Re: Site Plan Application for Ground-Mounted Solar Photovoltaic Project, 327 South River Road
Response to Comments

On behalf of the Applicant, WR-TGC Solar Generation XVI, LLC (TGC), we are submitting this response to comments on the Site Plan Application for the proposed solar project at 327 South River Road in Tolland, Connecticut. Comments were received via email on March 21, 2016, from Janet Carter Bernardo, PE, Senior Project Manager at Horsley Witten Group (the Town of Tolland Third-Party Reviewer). These comments have been provided below in italics, followed by our response:

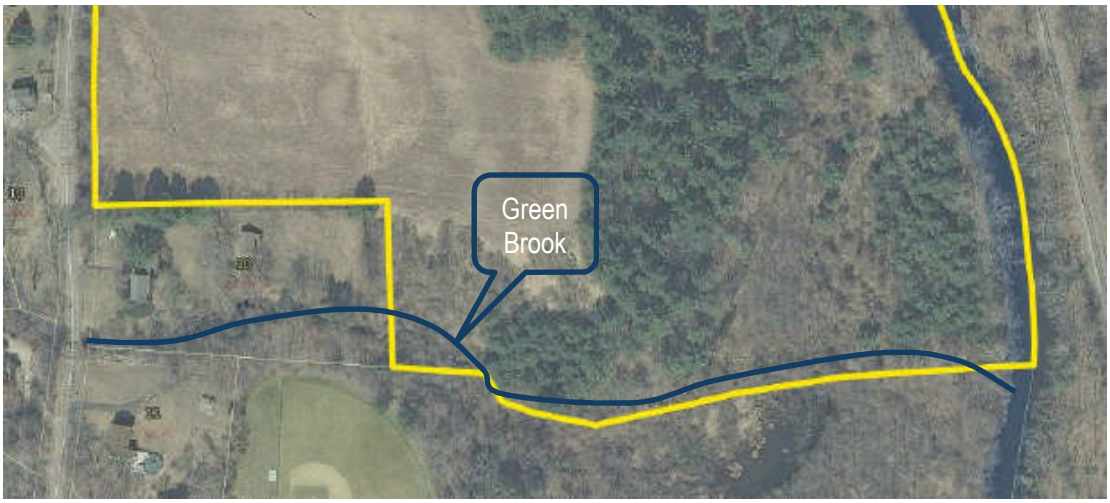
8. *On the USGS locus there appears to be a stream along the south property line. Green Brook appears to discharge to the Willimantic River. It appears that the parcel being developed flows towards this stream; however the proposed connection is not clear. The proposed stormwater basin is designed to overflow via a 20 foot level spreader directed towards the property at 343 South River Road. HW recommends that the Applicant verify the location of the stream on the property owned by the Town of Tolland and confirm that the proposed flow is contained within the property boundaries prior to discharging to Green Brook.*

Green Brook crosses the property at 343 South River Road and is located along the southern edge of the property owned by the Town of Tolland prior to discharging to the Willimantic River, as shown in the following screenshot of the Town's GIS Map of the site:

The proposed project will not discharge directly to Green Brook. Under pre-development conditions, stormwater runoff from the site is conveyed via overland flow onto the property at 343 South River Road. The proposed project will continue to discharge stormwater runoff from the site onto the property at 343 South River Road. All runoff associated with the proposed development will be collected and contained within the proposed stormwater basin prior to discharging onto the abutting property. This basin fully retains stormwater volumes during the 2-year and 10-year storm events, and significantly reduces the peak rate of runoff for the 100-year event.

Pond 1P: Stormwater Basin

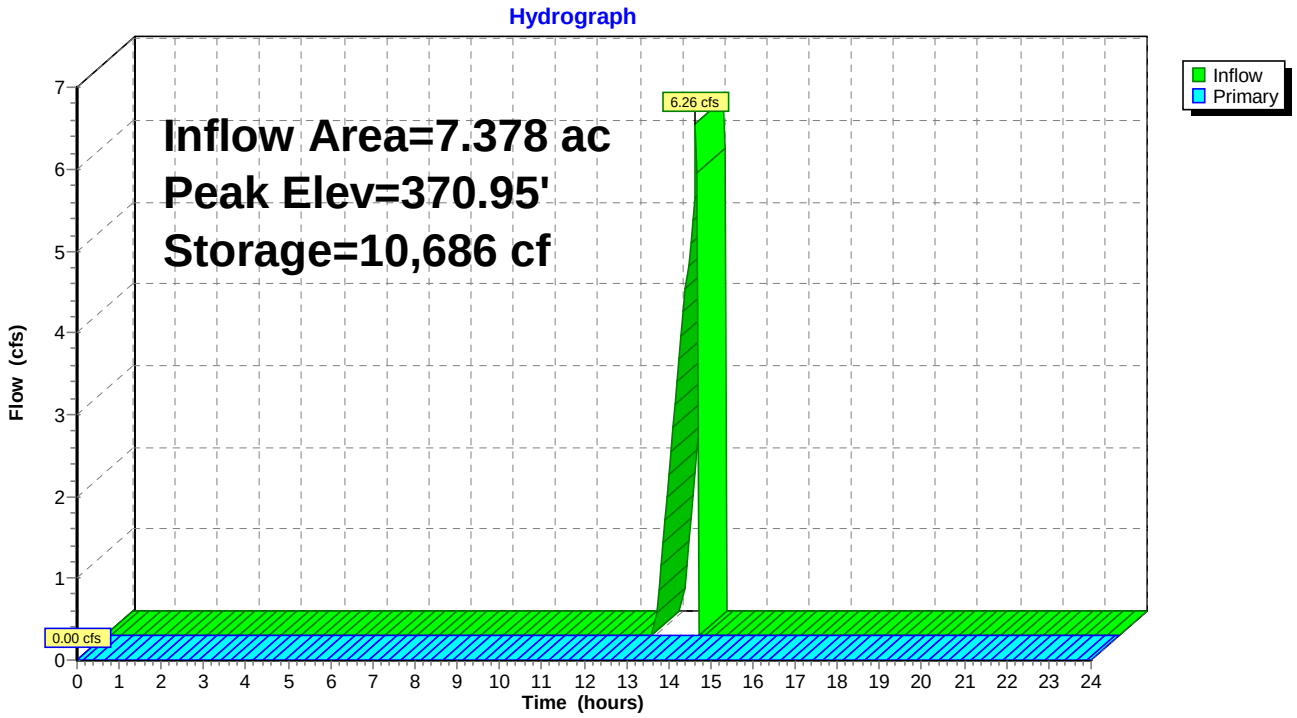
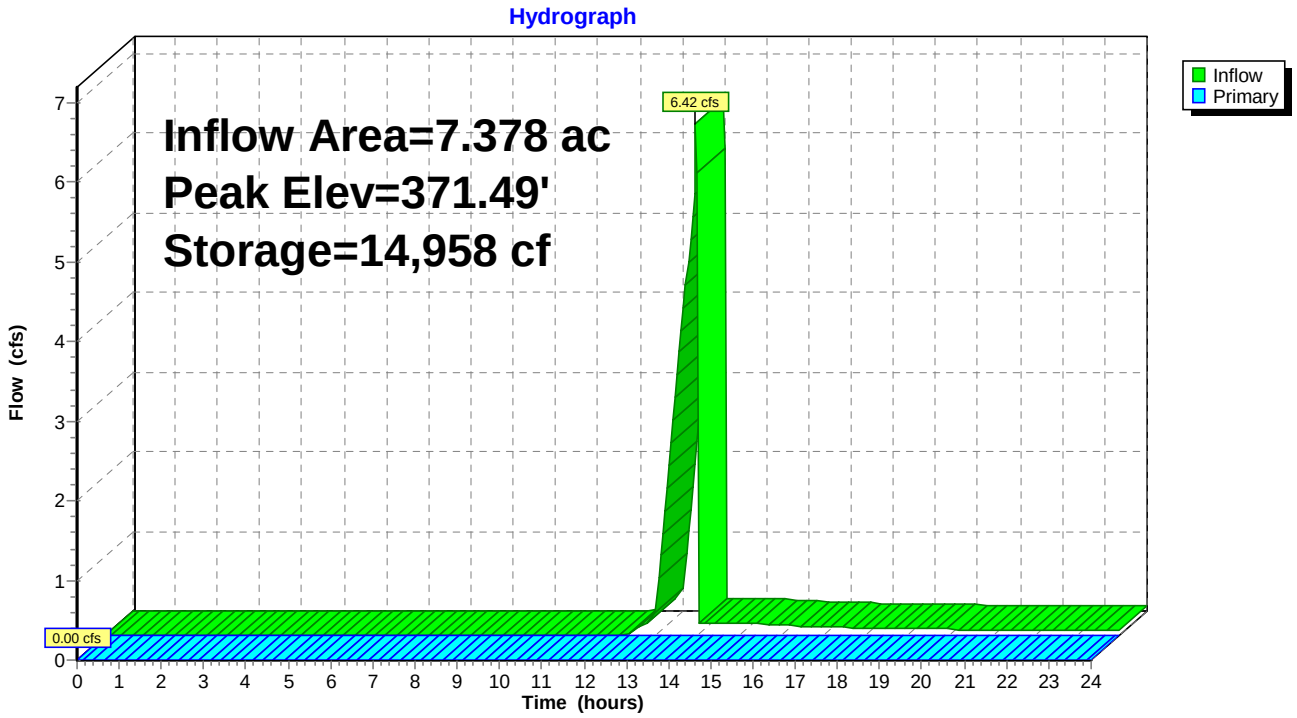
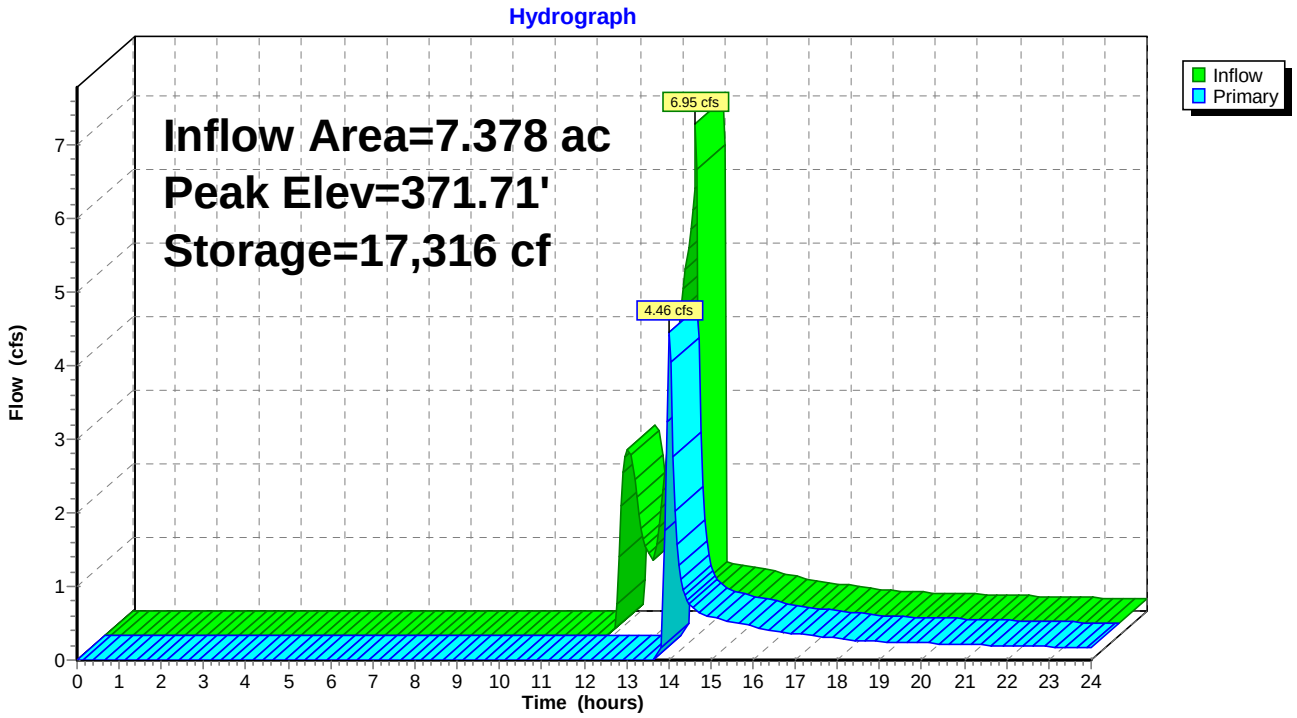
5. *It appears that the surface area values input for Pond 1P are not accurate. HW recommends that the Applicant verify the values provided and adjust the HydroCAD model as necessary.*

The surface area values input for Pond 1P have been verified and the HydroCAD model has been adjusted to accurately reflect the design drawings, and the stormwater calculations have been revised as described in our response to Comment #1 above.

SITE PLAN, GRADING AND EROSION CONTROL

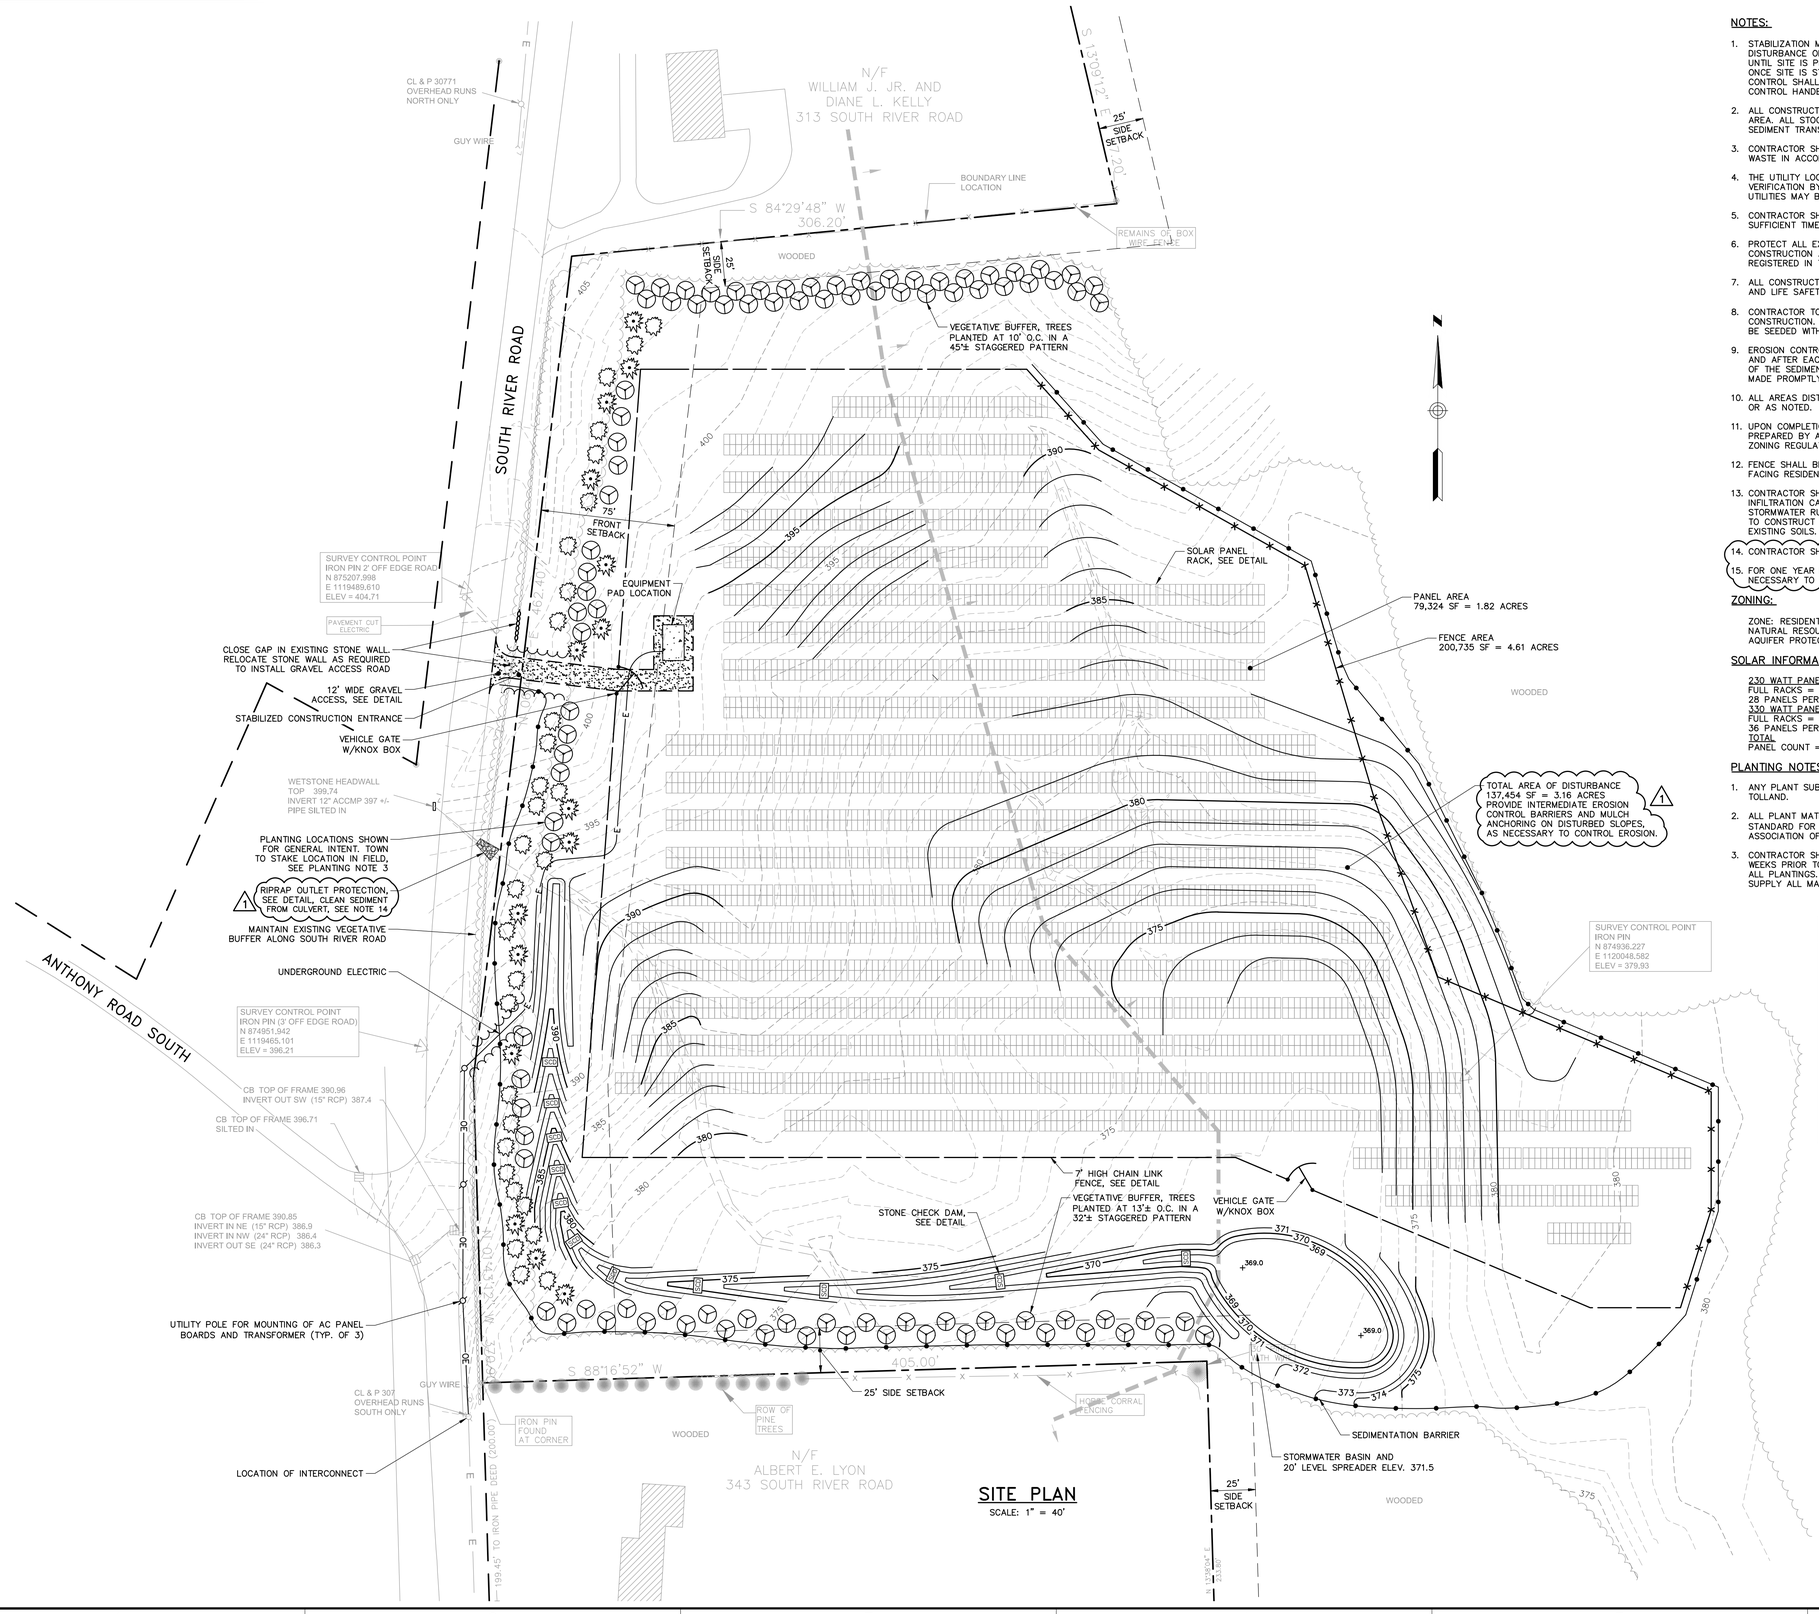
4. *As the functioning of the stormwater system depends on the area beneath the solar panels being maintained as grass, it is critical that the vegetation establishes quickly and any gullies that form before then are repaired as necessary. HW recommends that a note be added to the plans requiring the contractor to water the newly seeded areas for one year and reseed barren areas and repair gullies as necessary.*

9. *HW recommends that the Applicant provide permanent erosion control measures along the drip line of the solar panels to decrease the likelihood of scour from sheeting stormwater runoff from the panels.*

10. *HW further recommends the installation of temporary erosion control measures to effectively minimize exposed soils along the steep slopes.*

The attached O&M Plan requirements for maintaining grass cover specifies that newly seeded areas shall be watered for one year and that barren areas will be re-seeded. As described in the O&M Plan, a Ground Lease Agreement will be executed between the Town of Tolland (Lessor) and TGC (Lessee). As the Operator of the Site, TGC will be the responsible party for implementing the O&M Plan. These requirements have also been added as Note 15 on Sheet C-101.

A note has been added to Sheet C-101 requiring the installation of intermediate erosion control barriers and mulch anchors, as necessary. Furthermore, the Soil Erosion and Sediment Control Plan previously submitted as Appendix E of the Site Plan Application requires that mulch anchoring be applied as needed on slopes.

RIPRAP OUTLET PROTECTION
N.T.S.

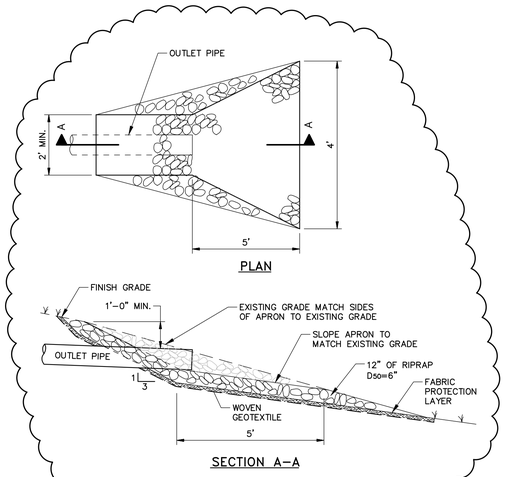
7. *The Applicant notes on the existing conditions plan that the 12-inch culvert pipe is silted in. HW recommends that the pipe be cleaned during the construction process and that rip rap be proposed at the outlet to protect the proposed swale against scour from high flows exiting the culvert.*

Note 14 has been added to Sheet C-101, which specifies that the Contractor shall clean the existing 12-inch culvert. Additionally, riprap outlet protection has been noted at the outlet of the existing 12-inch culvert; a detail is provided on Sheet D-200. The revised design drawings are attached.

LEVEL SPREADER DETAIL

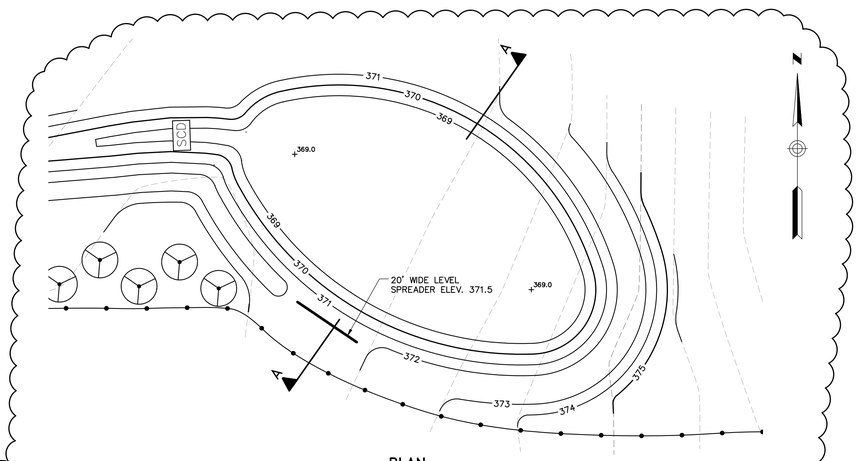
11. *HW recommends that a detail for the proposed level spreader be included on the Details sheet of the plan set. The detail should include notes on material, length, width, depth and installed top of spreader elevation.*

A Level Spreader detail has been added to Sheet D-201, which specifies the material, dimensions, and elevation of the level spreader. The revised design drawings are attached.
